Enka Campus TCC Building Roof Replacement
Buncombe County Government
A-B Technical Community College

Addendum #2

AS.01 Sheet S101, Overall Roof Layout Plan, area B (see sketch below)

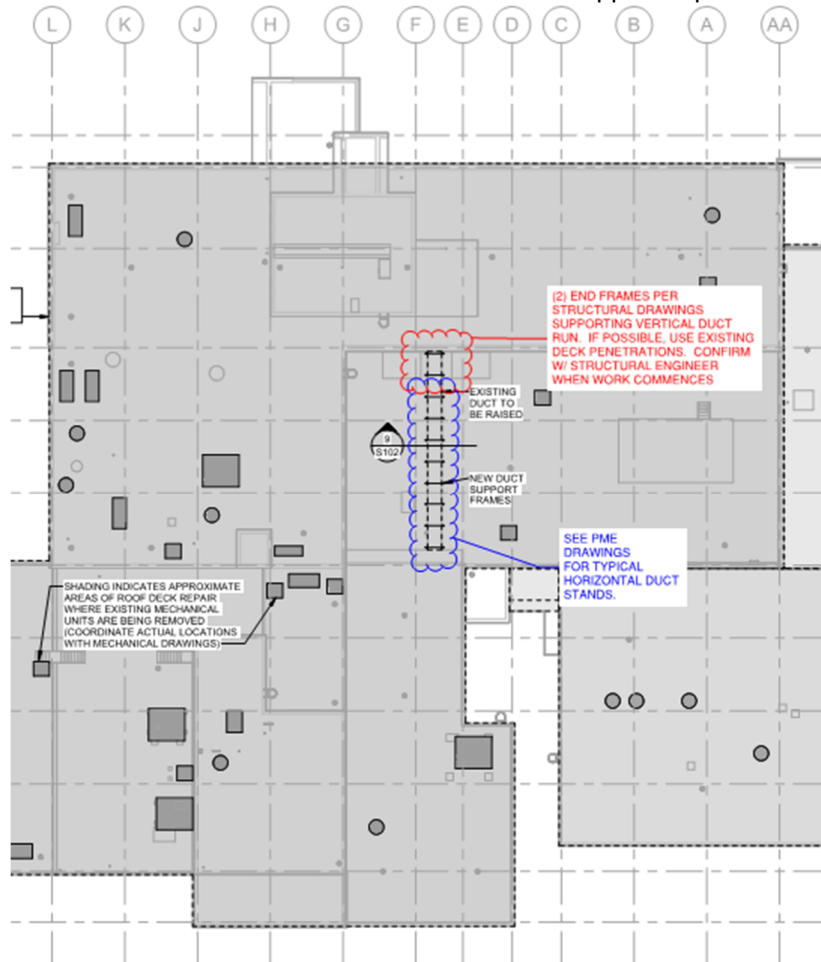
1. (2) Plan N steel frames supporting raised vertical duct run per structural drawings. Use existing deck penetrations if possible. See sketch below in red. Confirm final layout with EOR.
2. Raised horizontal duct run supported per Mechanical drawings. See below in blue.
